SERVICE BULLETIN

APPLICABILITY: 2013MY BRZ

NUMBER: 09-54-12R

SUBJECT: High-Pitched “Chirp,” “Squeak” or “Cricket”
 Sound from the Engine

PART INFORMATION

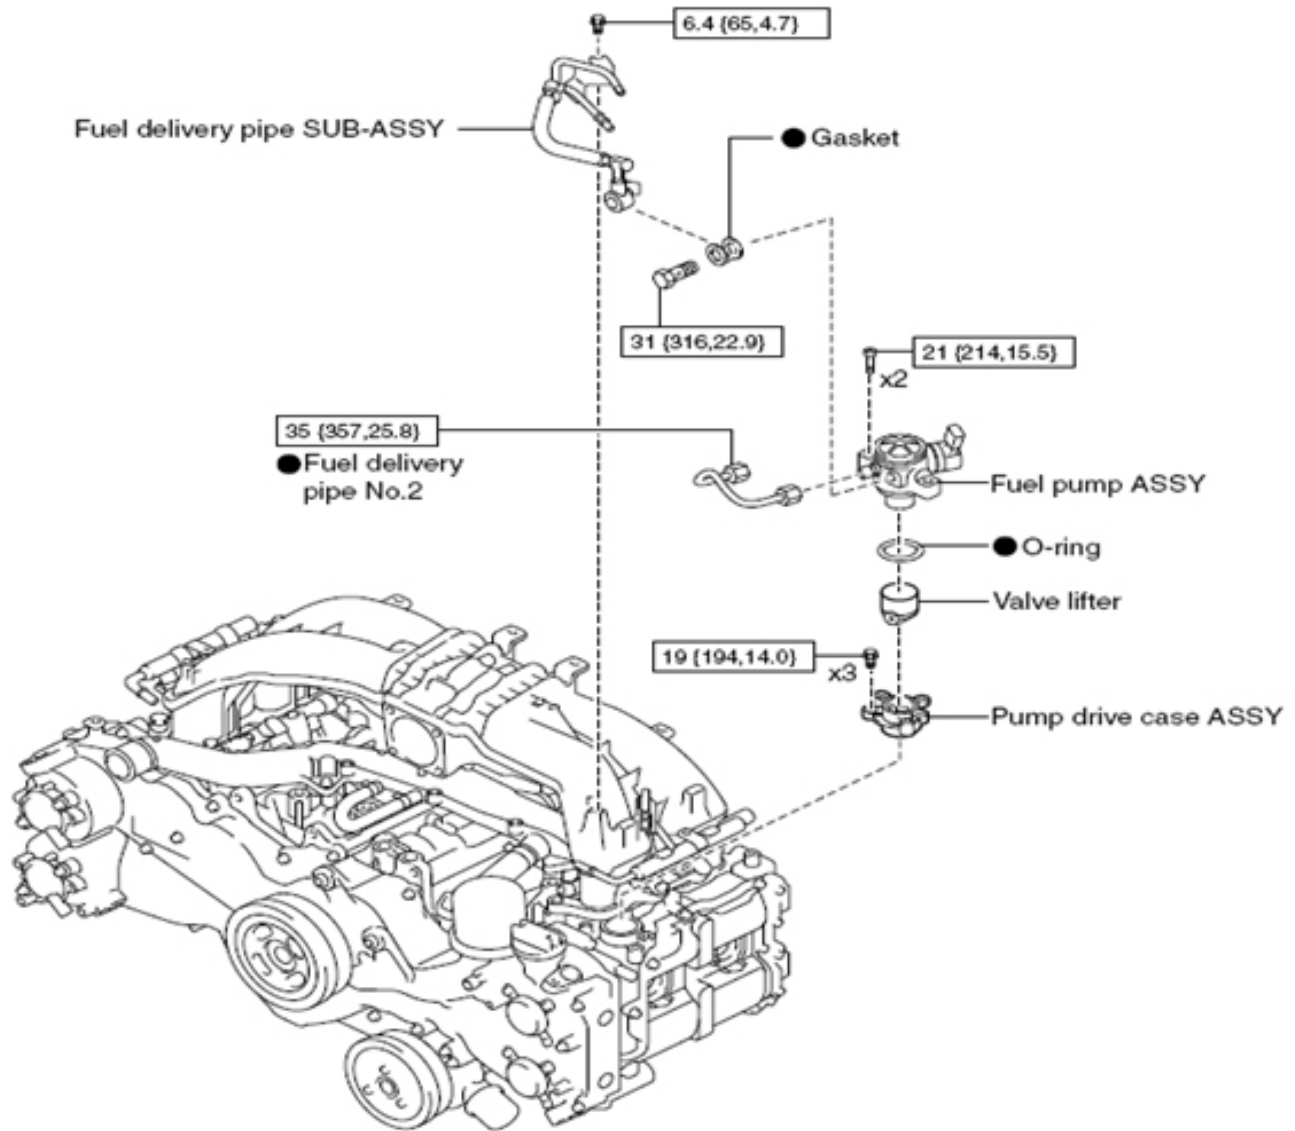
- Items indicated in the exploded view with a ● are “non-reusable” and **MUST** be replaced.
- The o-ring is included with the fuel pump assembly.
- Part numbers and quantity required to complete the procedure are listed below.

IMPORTANT: Always follow the tightening torque specifications as indicated in the applicable Service Manual (and the exploded view diagram on pg. 2) during re-assembly.
